Access Compliance Report

(Curb Ramps)

Intersection ID: 19953	Main Street: ARCHDALE_DR	Cross Street: OLD_PINEVILLE_RD	Location: NE
ADA ID: E6323ACF9A7F	Ramp Type: Perp	Initial Pass/Fail: Fail	Overall Compliance: No
		Severity Score: 8.75	
Codes/Mitigation Info/Possible Solution		Field Measurements/Component Compliance

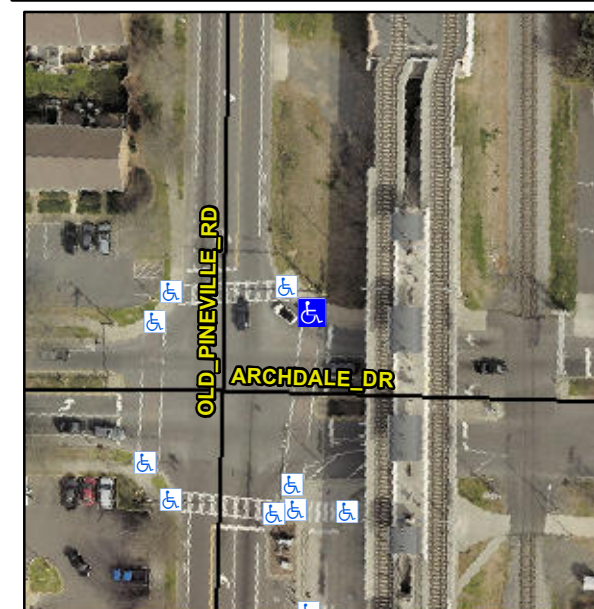
Not Found, R304.5.1

Compliance	Description	Data	Compliance	Description	Data
N/A	Ramp Length (in)	96.0	Yes	Ramp Slope (%)	5.8
No	Ramp Width (in)	46.5	Yes	Ramp XSlope (%)	2.0
N/A	Flare Type LT	N/A	N/A	Flare Type RT	N/A
N/A	Flare Slope LT (%)	N/A	N/A	Flare Slope RT (%)	N/A
N/A	Flare Traversable LT?	N/A	N/A	Flare Traversable RT?	N/A
N/A	Landing Length (in)	N/A	N/A	DWS Provided?	N/A
N/A	Landing Width (in)	N/A	N/A	DWS Contrast?	N/A
N/A	Landing Slope (%)	N/A	N/A	DWS Length (in)	N/A
N/A	Landing X Slope (%)	N/A	N/A	DWS Full Width?	N/A
N/A	Landing Curb? (Y/N)	N/A	N/A	DWS Offset (in)	N/A
N/A	Shared Landing?	N/A			
N/A	Gutter Ponding?	N/A	N/A	Gutter Slope (%)	N/A
N/A	Gutter Lip Ht (in)	N/A	N/A	Gutter X Slope (%)	N/A
N/A	Painted X Walk1?	Yes	N/A	Painted X Walk2?	N/A
	X Walk 1 Direction	To SW		X Walk 2 Direction	N/A
N/A	X Walk 1 Width (in)	111.0	N/A	X Walk 2 Width (in)	N/A
	X Walk 1 Slope (%)	2.1		X Walk 2 Slope (%)	N/A
	X Walk 1 X Slope (%)	1.9		X Walk 2 X Slope (%)	N/A

Remove & Replace Entire Ramp.
